**Tender for Construction of Industrial Work Shed Buildings and Amenities for  
the Common Facility Center of Krishnagiri Coir Cluster**

**CORRIGENDUM-1 dated 01.02.2020**

**RESPONSE TO PREBID QUERIES**

# ELECTRICAL DRAWING , FOR M/S-"KRISHNAGIRI COIR CLISTER PRIVATE LTD"

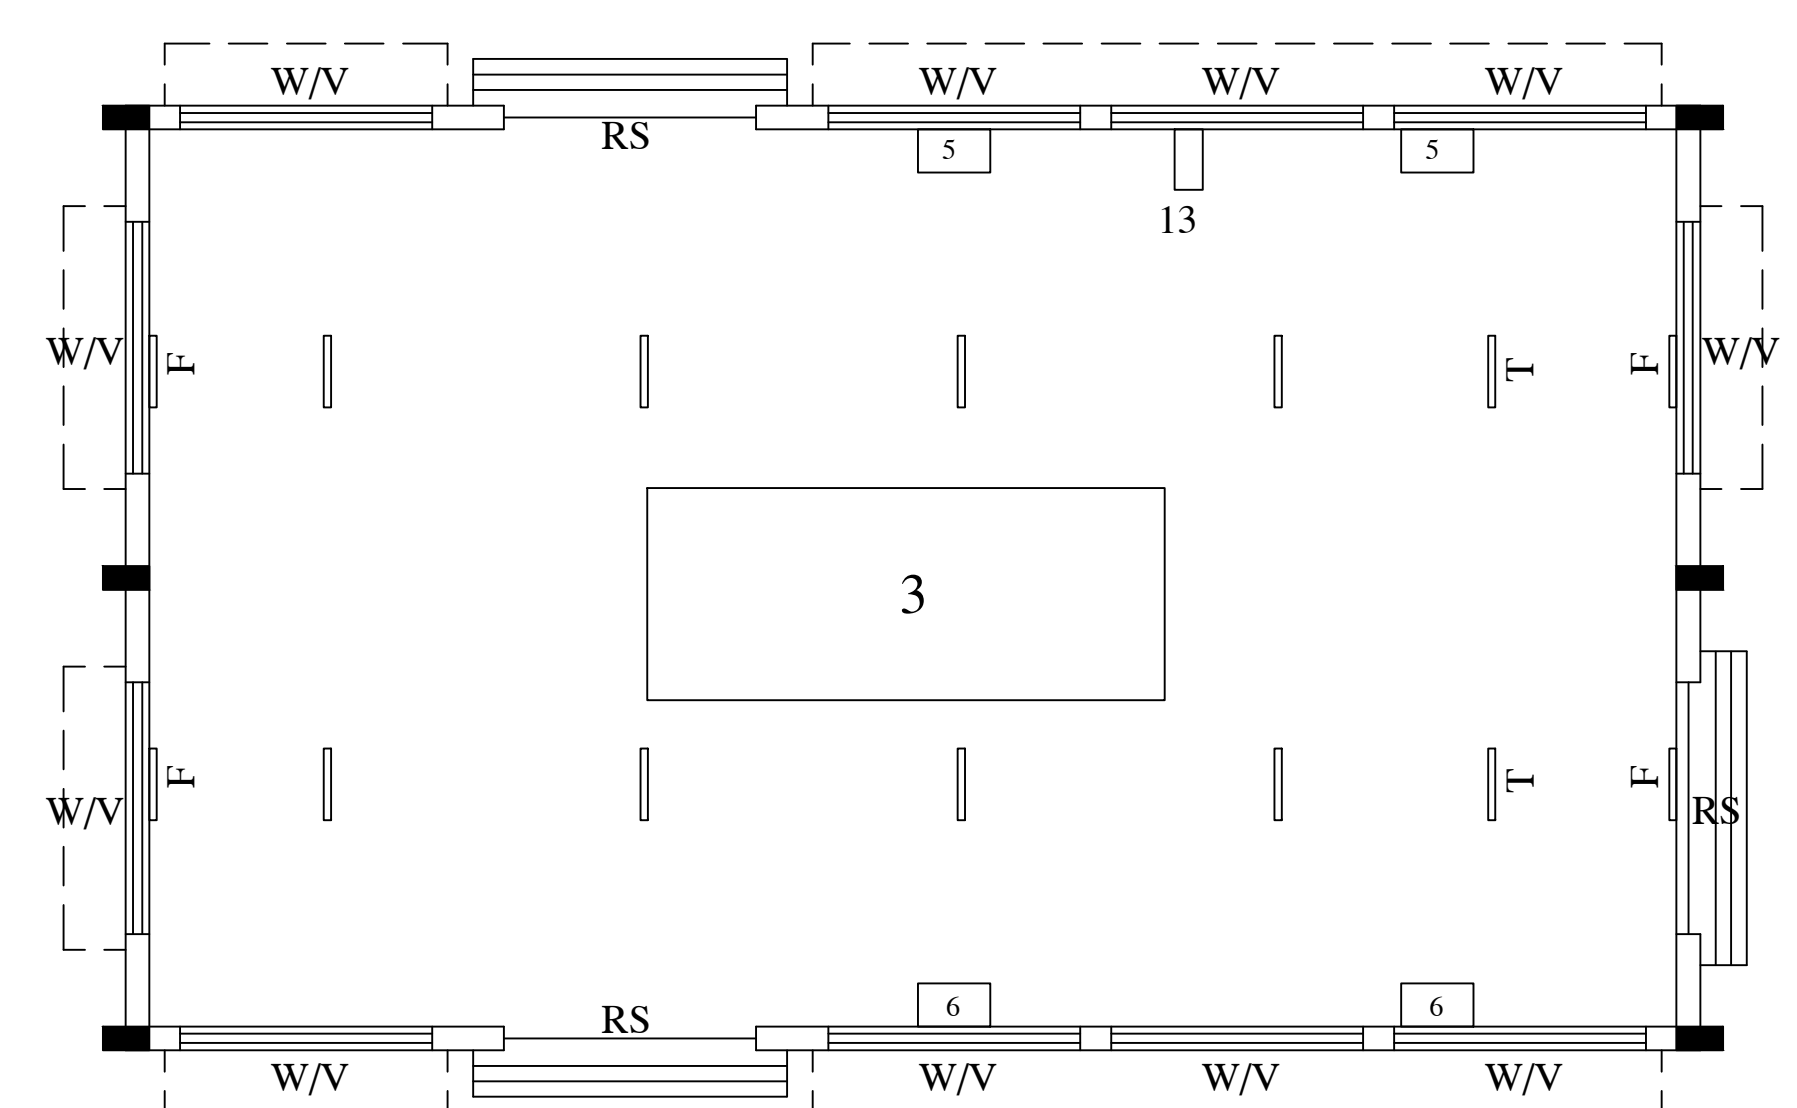
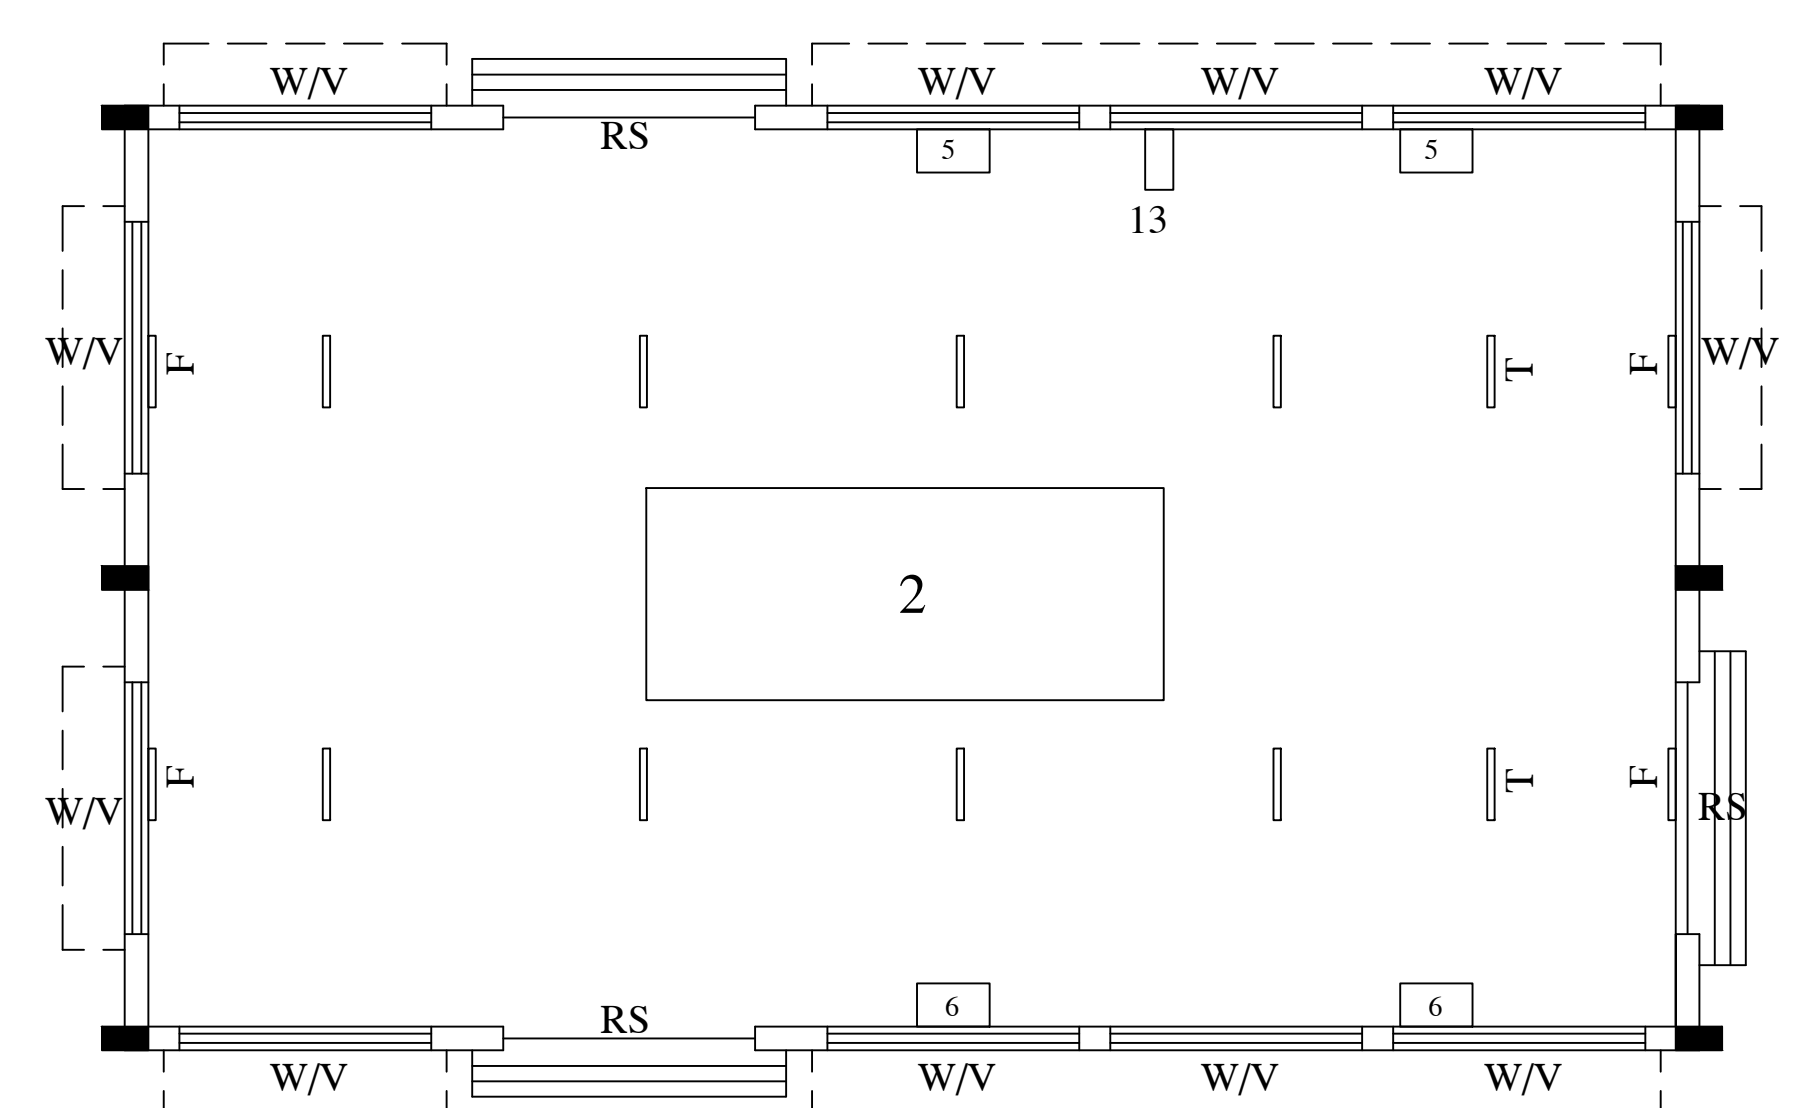
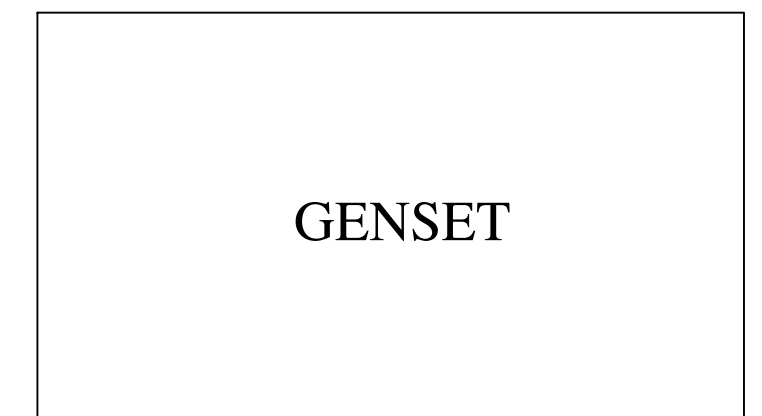
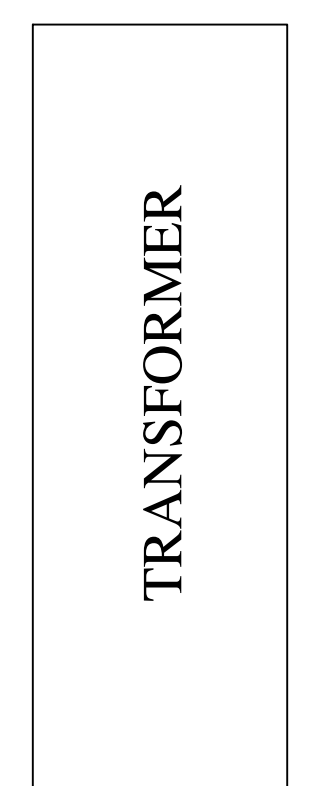
<b>S.No</b>	<b>Page No</b>	<b>Clause No.</b>	<b>Existing Clause</b>	<b>Revised Clause</b>
1.	13	Annexure – I	(To Add)	Schematic drawing for electrical arrangements are included in tender document.

<b>Sl. No</b>	<b>Clause No.</b>	<b>Clarification Sought</b>	<b>Pre-Bid Query Response</b>
1.	Page No.12 Annexure – I	Electrical work specification required	Schematic drawing for electrical arrangements are included in tender document (Refer Corrigendum 1)
